Report to the Plan Commission

Legistar I.D. #24825
3010 Shady Oak Lane, Town of Verona
Extraterritorial Certified Survey Map

Requested Action: Consideration of a two-lot Certified Survey Map (CSM) of the Keryluk-Wee property located at 3010 Shady Oak Lane, Town of Verona, in the City of Madison's Extraterritorial Jurisdiction.

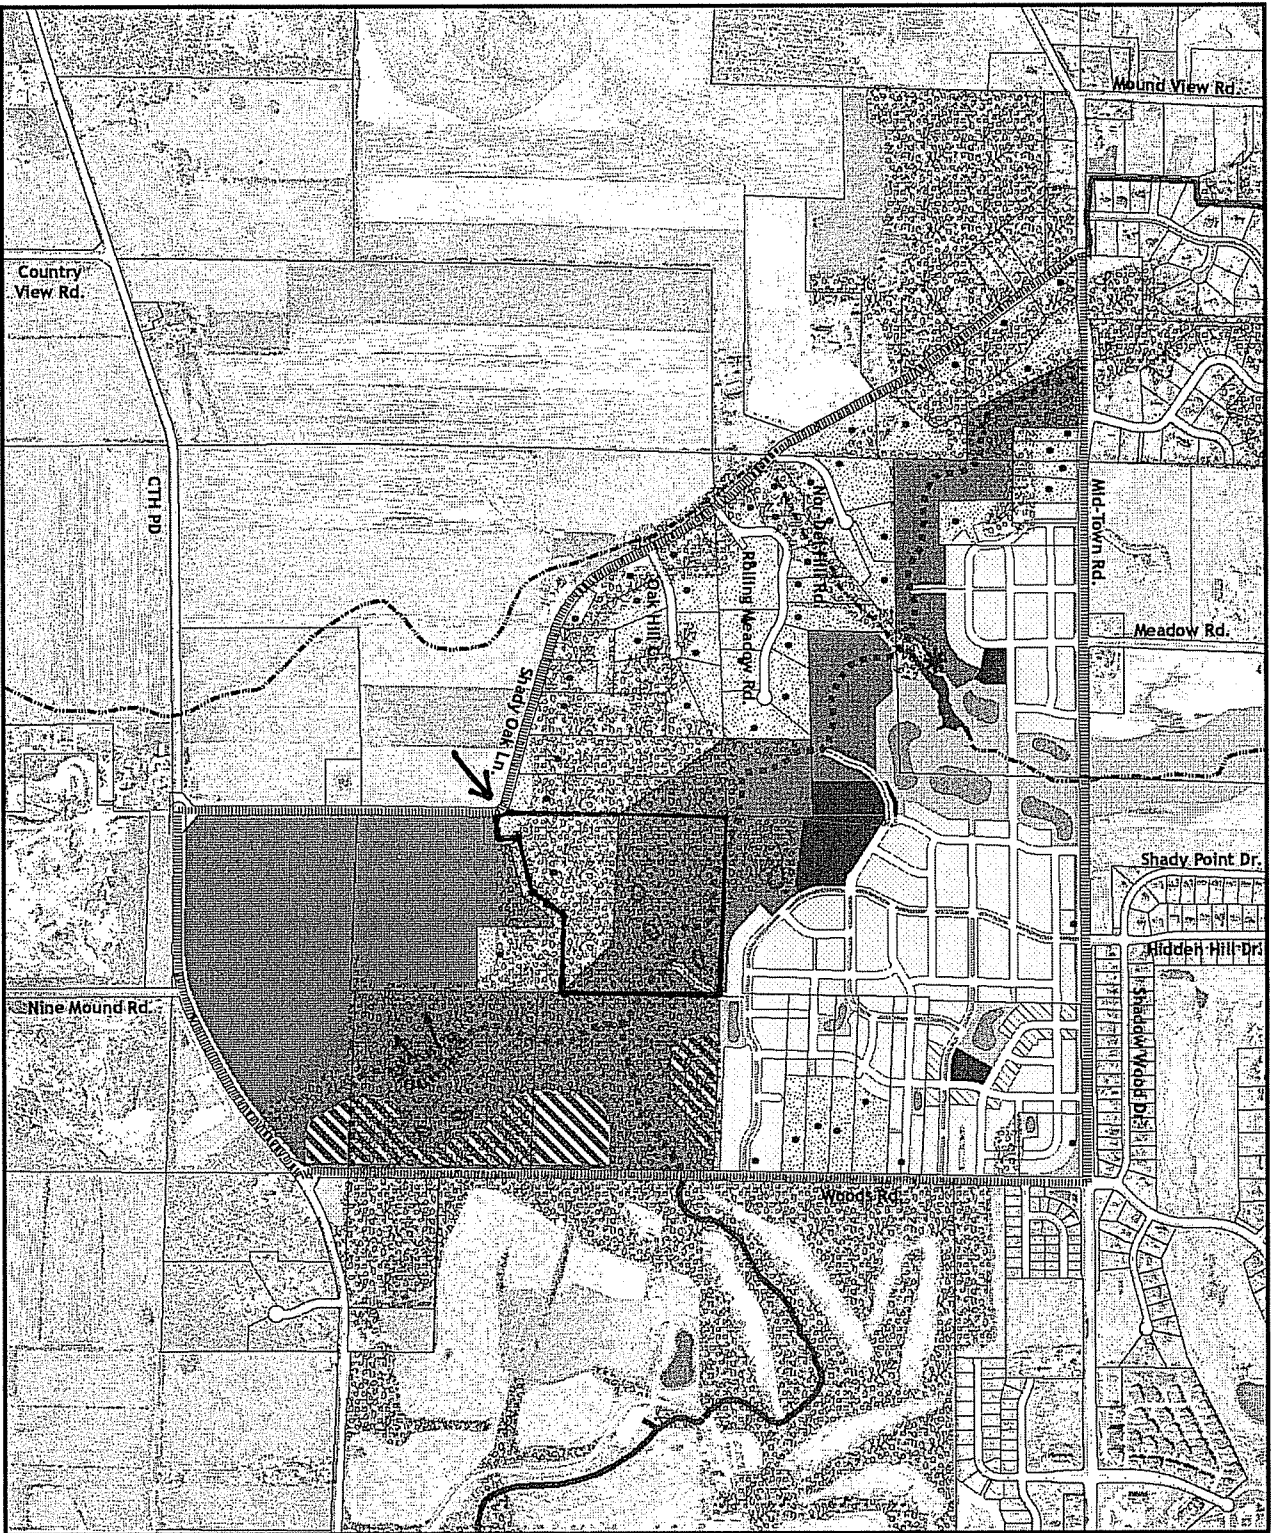
4. Place a note on the CSM stating the following: "Lot 1 and Lot 2 acknowledge they are dependent on each other for cross drainage."
5. Remove the reference to 12-foot drainage easements on page 2 and remove paragraph B of the drainage notes on page 3. NOTE: City Office of Real Estate Services comments requested the inclusion of language referring to "dedication" within the Owner's Certificate relating to these easements. With City Engineering suggesting the removal of these easements, this language is not required in the owner's Certificate unless there is intent to dedicate the portion of Shady Oak Lane to the public.

6. Include the land tie to the PLSS corner at the SW Corner Sec. 4-6-8. Based on dimensions shown on this CSM, this distance omitted from this CSM computes to 947.36 feet. This matches the tie for prior CSM 12342, yet differs from the 948.14-foot dimension for the same common line on CSM 13174. Make any necessary corrections to all recorded documents.
